ASTORIA CITY COUNCIL

SUBJECT: APPEAL AP18-05 BY MARK HOLLANDER, HOLLANDER HOSPITALITY OF
DESIGN REVIEW COMMITTEE REQUEST DR18-01R AT 1 2ND STREET

FINDINGS OF FACT

SUBJECT: APPEAL (18-05) BY HOLLANDER HOSPITALITY OF DESIGN REVIEW REQUEST (DR18-01R) BY CRAIG RIEGELNEGG ON BEHALF OF CARLETON HART ARCHITECTURE FOR HOLLANDER HOSPITALITY TO CONSTRUCT AN APPROXIMATE 29,614 SQUARE FOOT, FOUR STORY HOTEL AT 1 2nd STREET

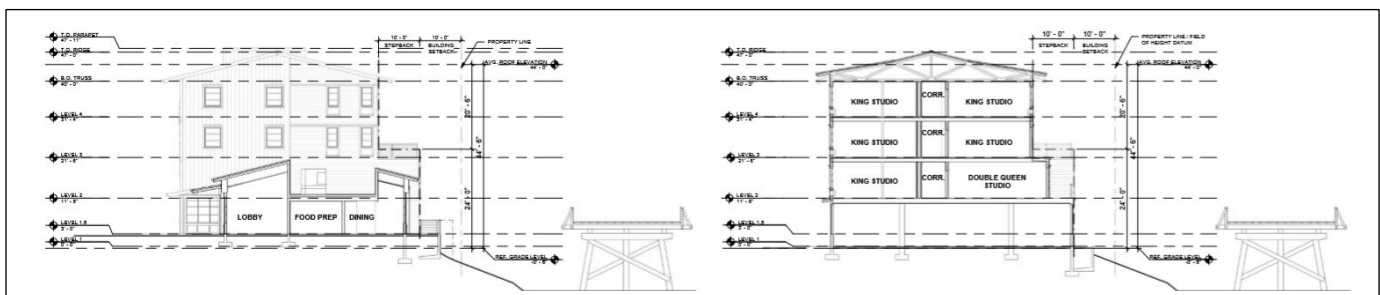
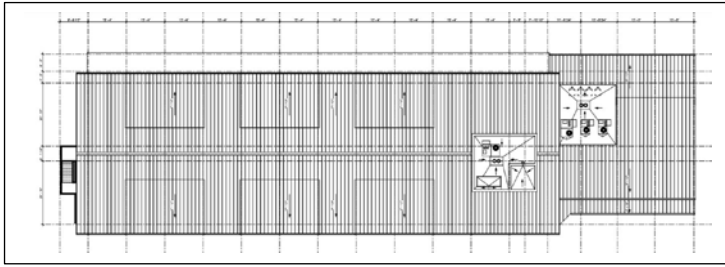
Building Height: The height of the mid-point of the highest pitched roof would be 44.5' based on Development Code Section 1.400 on definition of Building Height. With a pitched roof, the height of a building is the average height of the highest gable of a pitched or hipped roof (*Article 1.400 Height, Building*). The mechanical equipment will be hidden within a roof-top enclosure with a height of 47' 11" as allowed by Development Code Section 3.075, Exceptions to Building Heights. The east portion of the building would be 21.5' to the ridge of the clearstory roof.

Finding: The proposed building would be 44’ 6” to the midpoint of the gabled roof as measured in accordance with Section 1.400. The building is over 24’ high and all areas above 24’ have been stepped back 10’ from the north facade. The elevator shaft and mechanical equipment enclosures will be a height of 47’ 11” as allowed by Development Code Section 3.075, Exceptions to Building Heights. This criterion is met.

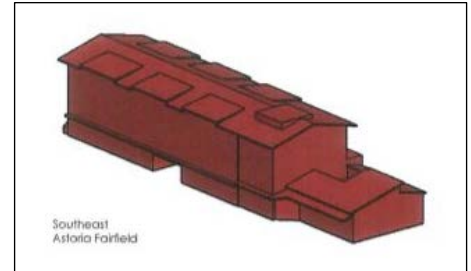
- J. Section 14.115.B.2.f, Guidelines for All Uses, states *“Building forms should be simple single geometric shapes, e.g. square, rectangular, triangular.”*

Finding: A majority of the City Council concluded that the proposed hotel is a simple geometric shape, i.e., rectangle, and that by meeting this geometric requirement, the applicant has satisfied ADC 14.115.B.2.f. This standard does not, by its express terms, require anything further, including articulation or modulation. This criterion is met.

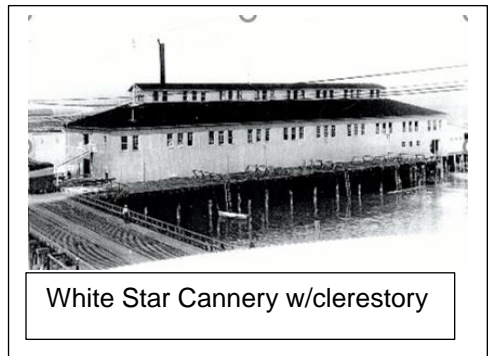
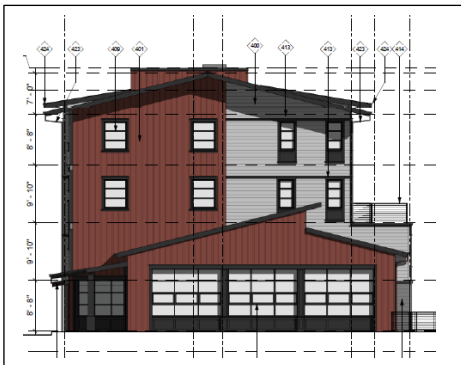
Finding: The main structure has a 3:12 pitch gabled roof, with six shed gables. The one-story east portion, lobby roofing incorporates a north facing clerestory with a 3:12 pitch. The clerestory is a type of skylight typically found on industrial buildings and was a common feature on the Astoria waterfront fishing industry buildings. These criteria are met.

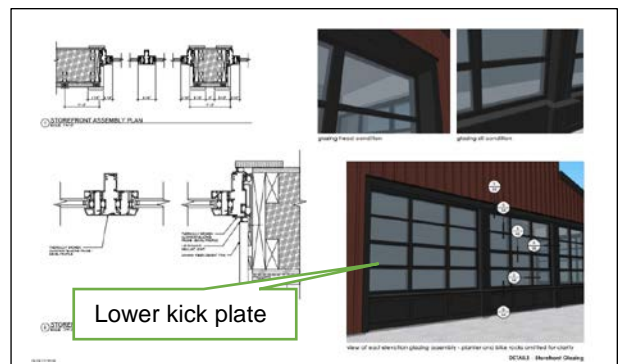
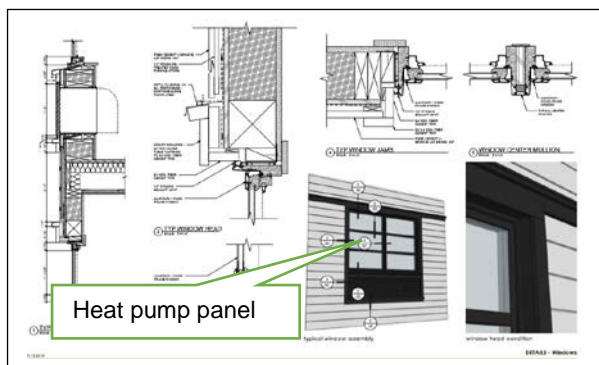
Finding: Room windows will be simulated six-lite casement with exterior muntins, recessed 3.5" from facade; black metal; crown moldings contiguous with belt courses between floor levels. Storefront window panels are fixed of 4 panel high x 3 panel wide true divided lites; black metal; recessed 3.5" from facade. Storefront windows will be awning or hopper style. All glass will be clear. All windows are aluminum. No vinyl windows are proposed. Fiber cement casings of 5/4" x 4" are proposed on all windows and doors. Bottom sills are set at 30" above the finished floor, except for storefront glazing at the Lobby/Entry, which is at 32". Storefront windows have a lower panel similar to a historic stucco kickplate appearance. Guest rooms will have heat pumps below the windows and will be black metal to match the windows with louvers that are flush with the facade. These criteria are met.

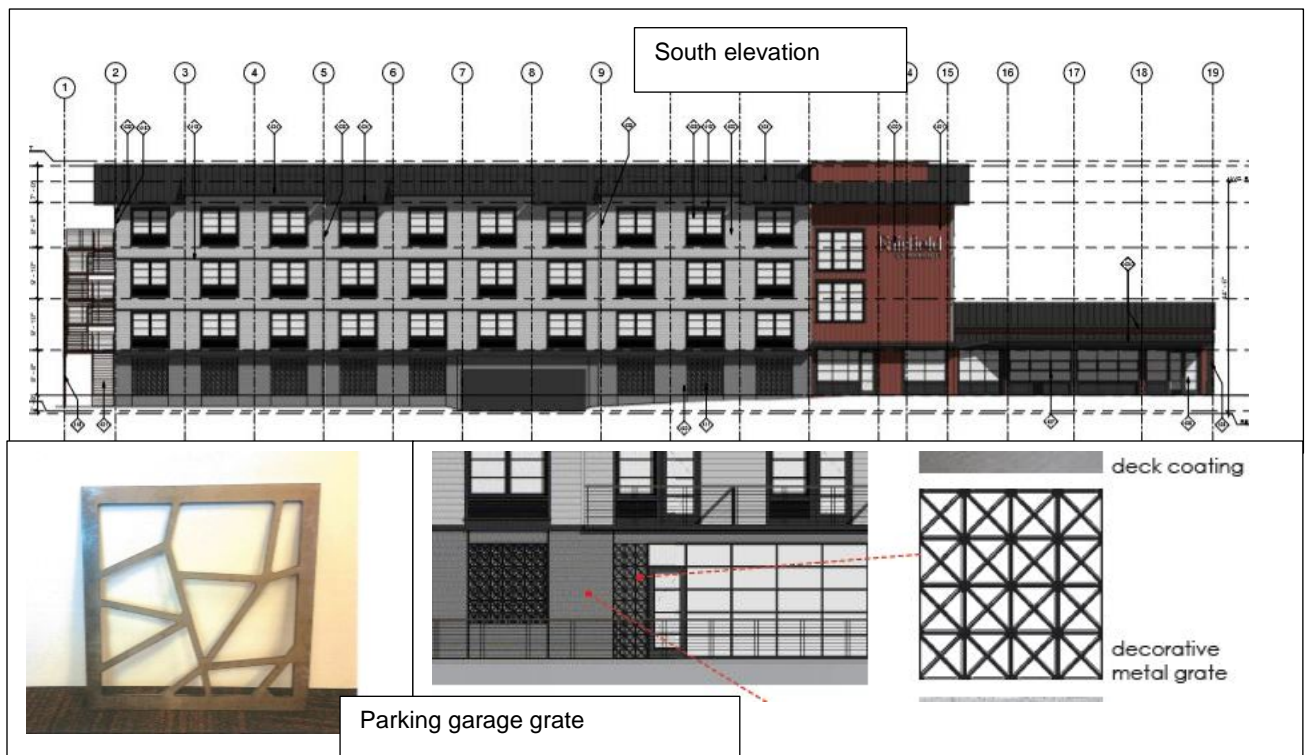
The west elevation does not meet the 30% window coverage but is not a street-facing facade.

The south elevation facing Marine Drive meets the required 30% window coverage for upper floors. The ground floor on the east end is mostly storefront windows. The remaining portion of the ground floor is the covered parking area. The applicant has submitted two designs for metal grates to create openings similar to windows by breaking up the siding in the facade. One grate is black with a 4x4 “X” pattern, and one grate is a silver/bronze irregular pattern. Either design would be acceptable. In considering these openings, the intent of the Code to not have large blank wall area is met.

The north elevation facing the River Trail is not street-facing but does face a main pedestrian route and RR right-of-way. While not required to meet the percentages, the north elevation is similar to the south elevation with the addition of two large ground floor window areas and meets the intent of the Code.

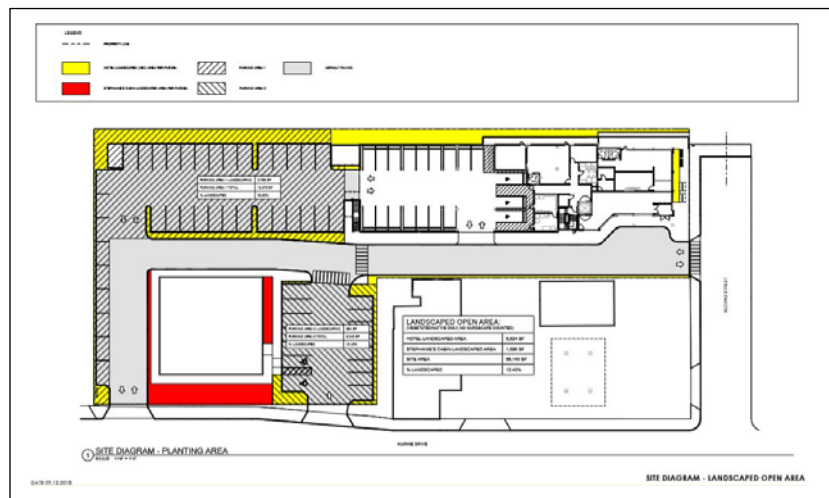
Finding: The County Assessor documents indicate the total site as 56,177 square feet. As required by the C-3 Zone, 10% (5,617 square feet) of the lot shall be landscaped. The calculations indicated on the plans show 7,120 square feet (12.7%) of site landscaping.

Final landscaping calculations will be made once the final site plan and proposed landscaping has been reviewed and approved by the Planner. The calculations as shown on the plans appear to meet the required percentages. Actual configuration and/or plant material may need to be altered to meet other code requirements during the planning and building permit review process. The applicant shall submit a final landscaping plan with materials and calculation for review and approval by the Planner prior to issuance of the building permit. All landscaping shall be installed prior to final inspection and/or any occupancy of the structure (Condition #5).
